# THE CLEVELAND ELECTRIC ILLUMINATING COMPANY

January 20, 1982

Perry Nuclear Power Plant  
Docket Nos. 50-440; 50-441  
Response to Request for  
Meeting - Instrumentation  
and Control Systems

Cold Reference Leg Water Level Instrument Piping Routing  
 TYPICAL FOR MARK III - BWR 6

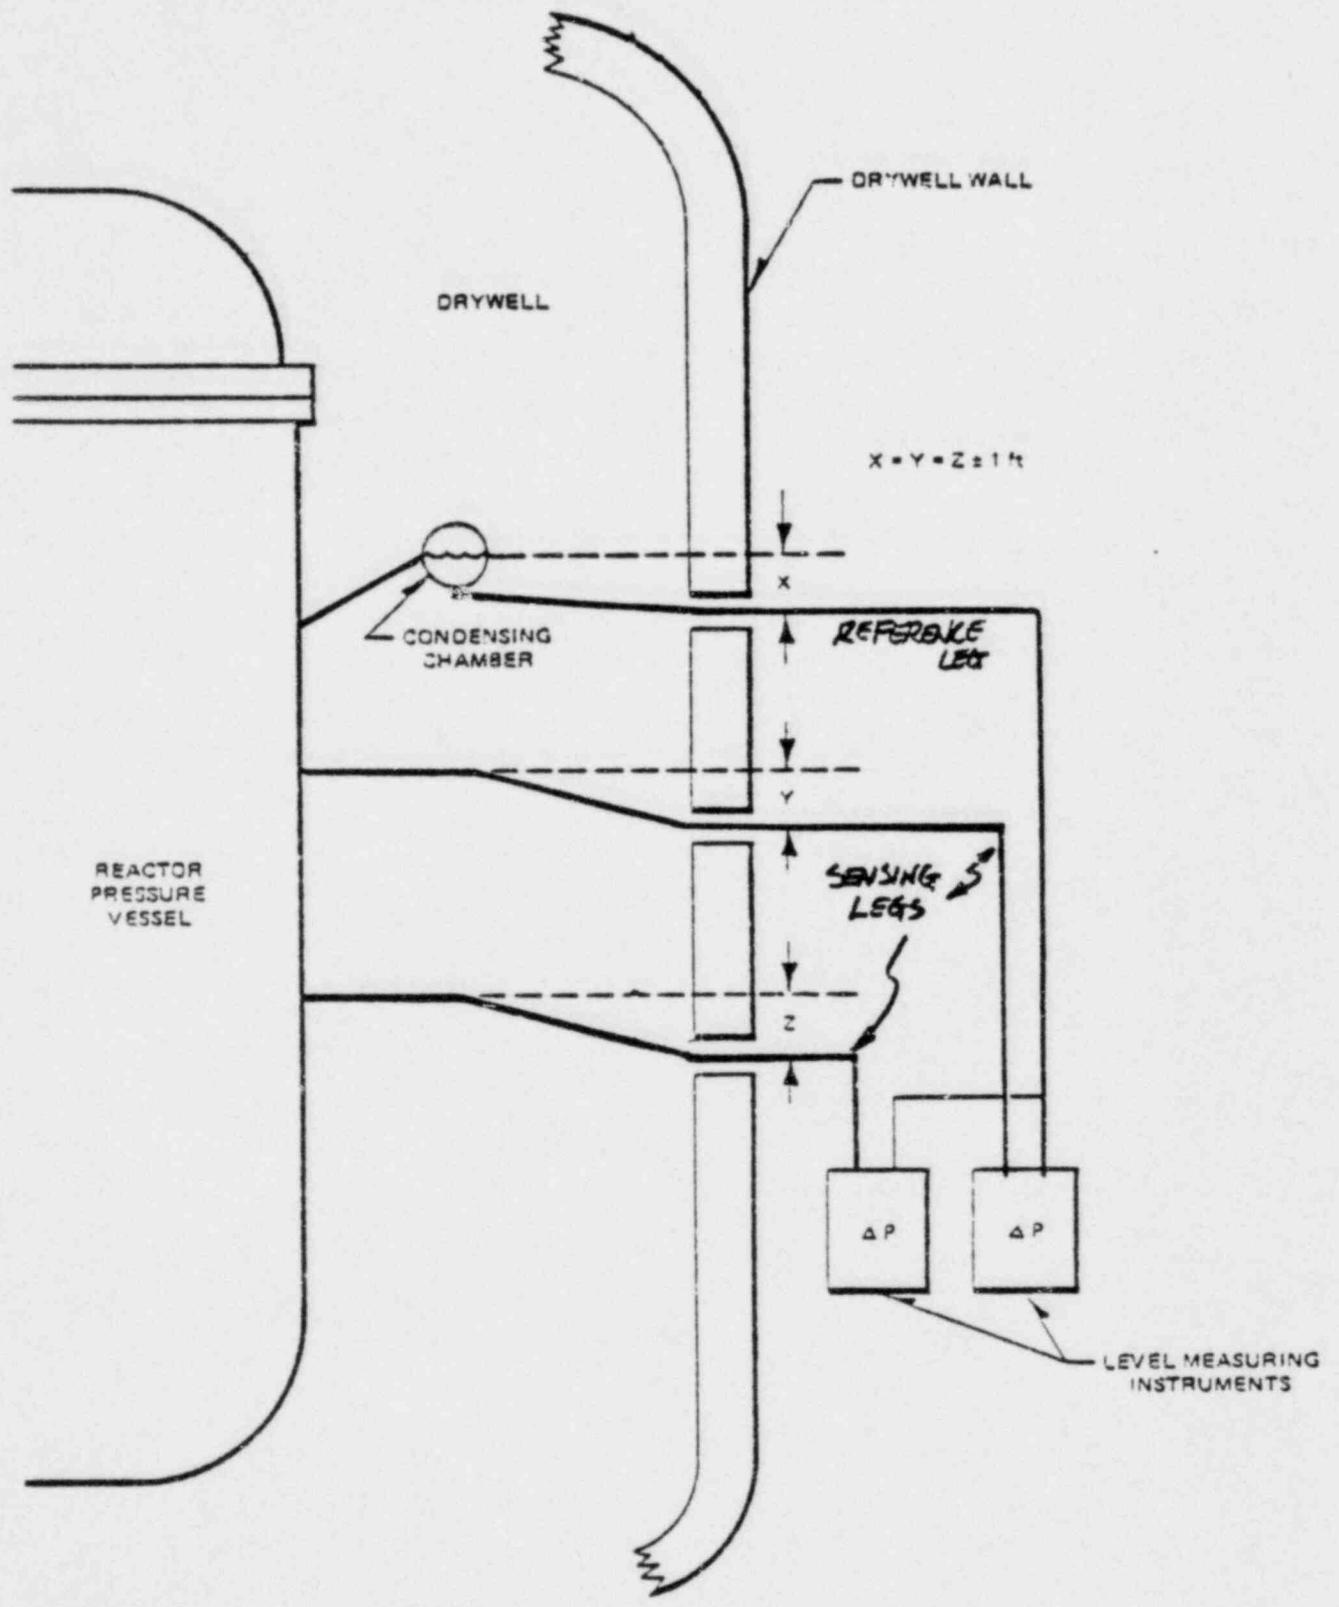
421.10 Provide an evaluation of the effects of high temperatures in reference legs of water level measuring instruments subsequent to high energy line breaks.

The Perry Nuclear Power Plant is of the BWR6-Mark III containment design which has the reactor vessel water measurement reference leg and sensing legs outside of the drywell as illustrated in the attached sketch.

Cleveland Electric has evaluated the potential for high drywell temperatures to cause errors in level sensing instrumentation. High drywell temperatures could produce errors in two ways:

- (1) By causing density changes in the water in the sensing lines due to increased temperature in the drywell.

These effects are accommodated in the design by making the vertical drop of the upper and lower sensing lines within the drywell essentially equal so that errors due to density changes resulting from increases in drywell temperature are minimal.

- (2) By boiloff of the reference leg when the reactor is depressurized below the saturation pressure of the reference leg temperature (drywell temperature). This effect can only be produced by small steam leaks in the order of  $0.01 \text{ ft}^2$  or less for an extended period of the time resulting in heatup of drywell and subsequently the sensing lines within the drywell. Larger breaks do not result in drywell temperature sufficiently high to cause potential problems due to the resulting high drywell pressure signal which will cause scram and depressurization of the RPV in several minutes or less. In the case of the highest drywell temperatures (assuming the operator has ignored), the RPV would have to be depressurized below 118 psia to start boiloff of the reference legs. The water in the sensing legs will always be refilled by the low pressure ECC pumps upon depressurization of the vessel.
